**Comanche Peak Nuclear Power Plant, Units 3 & 4
COL Application**

**Part 3,
Environmental Report
Update Tracking Report**

Revision 4

Figure 4.3-1 Ecological Cover Types Within Construction Footprint of CPNPP

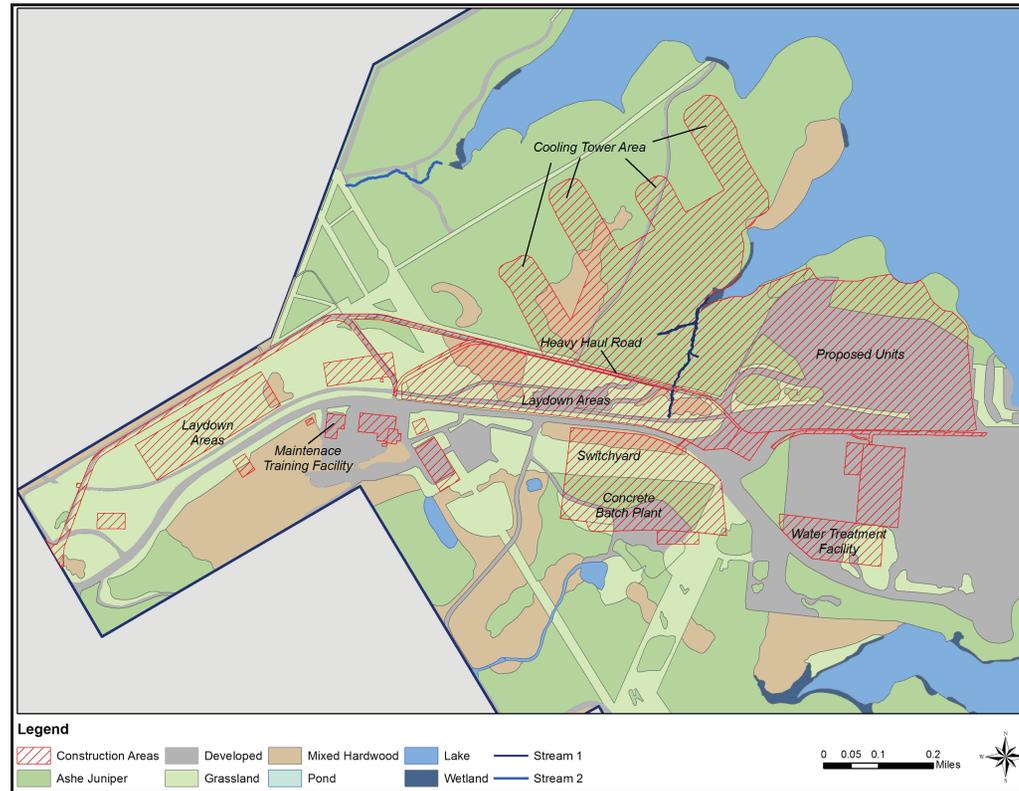
CTS-00711	Figure 4.3-1	--	Revise figure to show streams.	Revised figure to show streams.	4

Figure 4.4-1 CPNPP Total Project Staffing⁽¹⁾

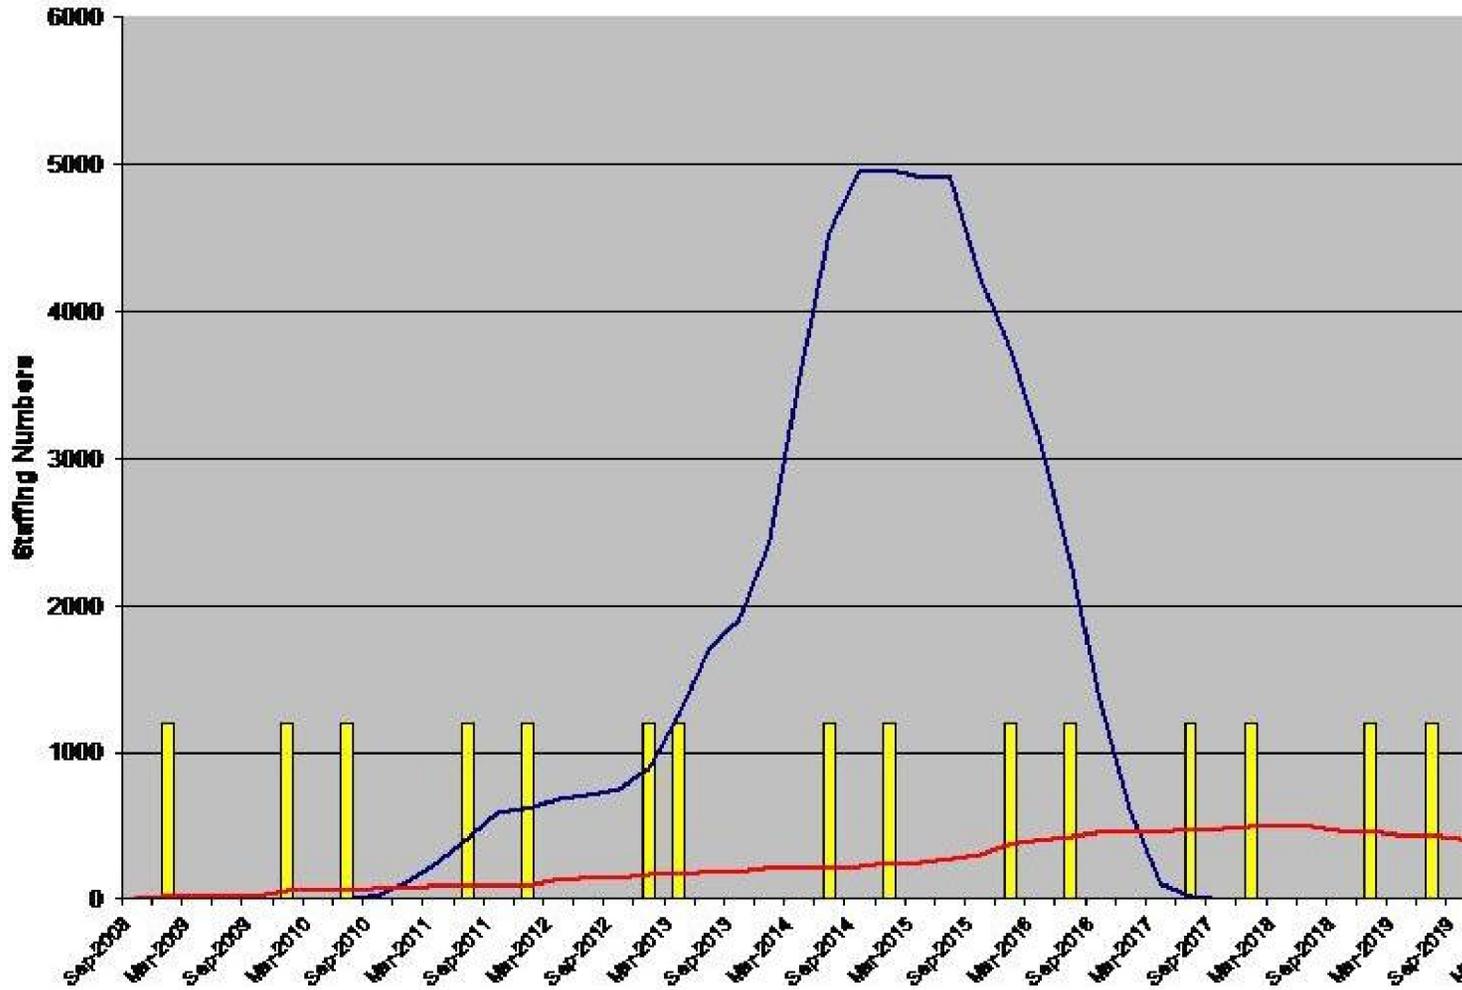
SOC-03	Figure 4.4-1		Increase information as discussed with the NRC	Added table to show total project staffing.	2
GEN-05 GEN-06 SOC-16 CR-03	List of Tables	4-v	Increase information as discussed with the NRC.	Added Table 4.9-1.	3
LU-10	Figure 4.1-1	--	Increase information as discussed with the NRC.	Revised figure to show batch plant contained within the property boundary.	3
